Access Compliance Report

Public Rights-of-Way

(Curb Ramps)

Intersection ID: 25717	Main Street: WOODLEIGH_OAKS_DR	Cross Street: WOODMERE_CROSSING_LN	Location: SW
ADA ID: 1E39BC6A6887	Ramp Type: Perp	Initial Pass/Fail: Fail	Overall Compliance: No
			Severity Score: 10

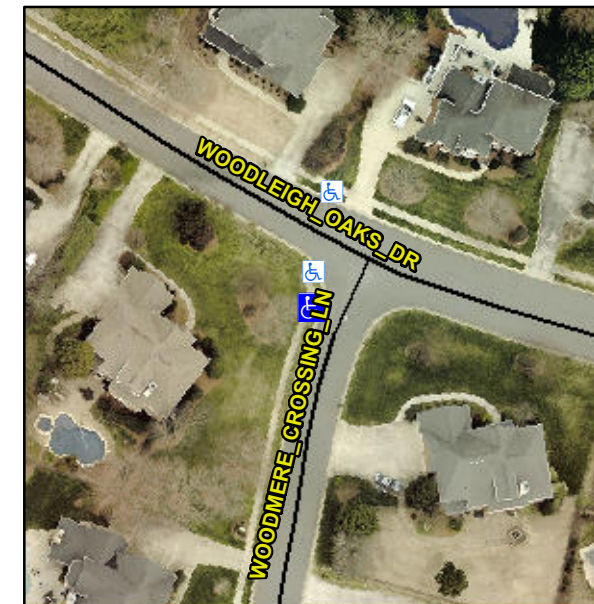
R304.5.1, R304.5.3

Compliance	Description	Data	Compliance	Description	Data
N/A	Ramp Length (in)	92.0	Yes	Ramp Slope (%)	6.2
No	Ramp Width (in)	37.0	No	Ramp XSlope (%)	3.9
N/A	Flare Type LT	N/A	N/A	Flare Type RT	N/A
N/A	Flare Slope LT (%)	N/A	N/A	Flare Slope RT (%)	N/A
N/A	Flare Traversable LT?	N/A	N/A	Flare Traversable RT?	N/A
N/A	Landing Length (in)	N/A	N/A	DWS Provided?	N/A
N/A	Landing Width (in)	N/A	N/A	DWS Contrast?	N/A
N/A	Landing Slope (%)	N/A	N/A	DWS Length (in)	N/A
N/A	Landing X Slope (%)	N/A	N/A	DWS Full Width?	N/A
N/A	Landing Curb? (Y/N)	N/A	N/A	DWS Offset (in)	N/A
N/A	Shared Landing?	N/A			
N/A	Gutter Ponding?	N/A	N/A	Gutter Slope (%)	N/A
N/A	Gutter Lip Ht (in)	N/A	N/A	Gutter X Slope (%)	N/A
N/A	Painted X Walk1?	No	N/A	Painted X Walk2?	N/A
	X Walk 1 Direction	To SE		X Walk 2 Direction	N/A
N/A	X Walk 1 Width (in)	N/A	N/A	X Walk 2 Width (in)	N/A
	X Walk 1 Slope (%)	0.6		X Walk 2 Slope (%)	N/A
	X Walk 1 X Slope (%)	0.2		X Walk 2 X Slope (%)	N/A

Remove & Replace Entire Ramp.
